Project	<b>IEEE 802.16 Broadband Wireless Access Working Group</b> < <a href="http://ieee802.org/16">http://ieee802.org/16</a> >
Title	Corrections for definitions of mini-subchannels
Date Submitted	<b>2004-11-01</b>
Source(s)	Intel.  Yuval Lomnitz <a href="mailto:Yuval.Lomnitz@intel.com">Yuval.Lomnitz@intel.com</a>  Uri Pearlmutter
Re:	IEEE P802.16REVd/D5-2004
Abstract	Corrects unclear definitions of mini-subchannels.
Purpose	Adopt changes.
Notice	This document has been prepared to assist IEEE 802.16. It is offered as a basis for discussion and is not binding on the contributing individual(s) or organization(s). The material in this document is subject to change in form and content after further study. The contributor(s) reserve(s) the right to add, amend or withdraw material contained herein.
Release	The contributor grants a free, irrevocable license to the IEEE to incorporate material contained in this contribution, and any modifications thereof, in the creation of an IEEE Standards publication; to copyright in the IEEE's name any IEEE Standards publication even though it may include portions of this contribution; and at the IEEE's sole discretion to permit others to reproduce in

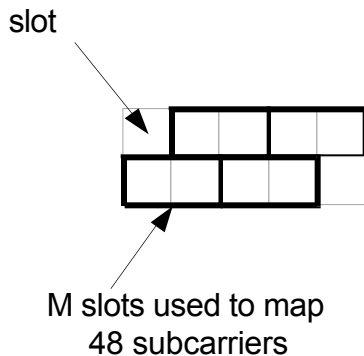
The problem is that if the number of slots in the UL subframe isn't a whole multiple of  $M$  (level of mini-subchannel division), the "extended" slots created by mini-subchannels are not aligned:

In this case it is not clear where the first group of 48 subcarriers, the second group and so on, are mapped.

One simple way of solving this problem is to refrain from allocating more than one full subchannel for mini-subchannel allocations. The reason is that mini-subchannels are used for narrowing the allocation and gaining power (due to the low number of tones). When allocating more than a full subchannel then in the overlapping symbols there are twice as many tones, and the result is decrease in transmission power (per tone) of 3dB. The same result would occur if the BS allocates a normal transmission with half the number of slots instead of mini subchannel with  $M=2$  (or in general case allocates mini-subchannels with  $M/2$ ).

There is still a problem that the "extended slots" are wrapped around the end of the UL subframe. This can be resolved by allocating data to the mini-slots according to their physical time order (the same way frequency-first mapping is defined in the UL per C80216d-04\_93r2)..

When mini subchannels of order  $M$  are indicated in the map, the allocation shall be a multiple of  $M$  slots, and shall not exceed one full subchannel, i.e. at most one slot will be allocated in each OFDMA symbol.

The slots in the allocation shall be numbered in time-first order in the same order as the slots are allocated in the map. The number of slot modulu  $M$  is used as index to table 312, and determines which tiles are allocated to the SS.
